HSA-10/B116

In your letter dated October 24, 2002, you requested formal Federal Highway Administration acceptance of a Low Profile Bridge Rail tested to NCHRP Report 350 test level 2 (TL-2). Included with your letter were copies of the Midwest Roadside Safety Facility report dated August 20, 2002, entitled "Development of a Low-Profile Bridge Rail for Test Level 2 Applications", a VHS video tape documenting the compliance test, and a CD-ROM containing digital photographs, film footage and system drawings.

MwRSF		Midwest Roadside Safety Facility	Low Profile Bridge Rail
DATE: 1/25/2001	Revised:	File Name: lowprofwall.dwg	
BY: Eric A. Keller			
SCALE: none		Sheet 01 of 02

End View

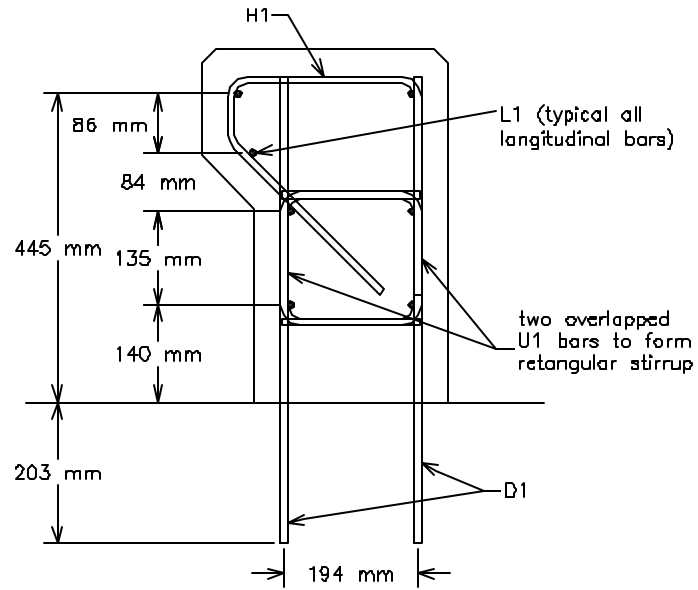
The tested rail was a 508-mm high reinforced concrete "curb" with a vertical back and a top width of 356 mm to a depth of 152 mm. This width was then transitioned back (on a 1:1 slope) to a 279-mm thickness, which then remained constant to the bridge deck. These dimensions (and reinforcing details) are shown in the enclosure to this letter. NCHRP Report 350 test 2-11 was run, with a 2000-kg pickup truck impacting the rail at 70 km/h and at an angle of 27.1 degrees. The vehicle was contained and redirected. Reported occupant impact velocity and ridedown accelerations were 6.6 m/s and 8.1 G's, respectively, both values being less than the preferred maximums suggested in NCHRP Report 350 guidelines. The roll angle of the truck was 36 degrees. Test 2-10 with the 820-kg car was deemed redundant based on previous tests with similar height barriers and I agree that that test can be waived in this instance.

The bridge rail described above can be considered an NCHRP Report 350 test level 2 (TL-2) design and used on the National Highway System at locations where anticipated impact speeds are in the 70-km/h range.
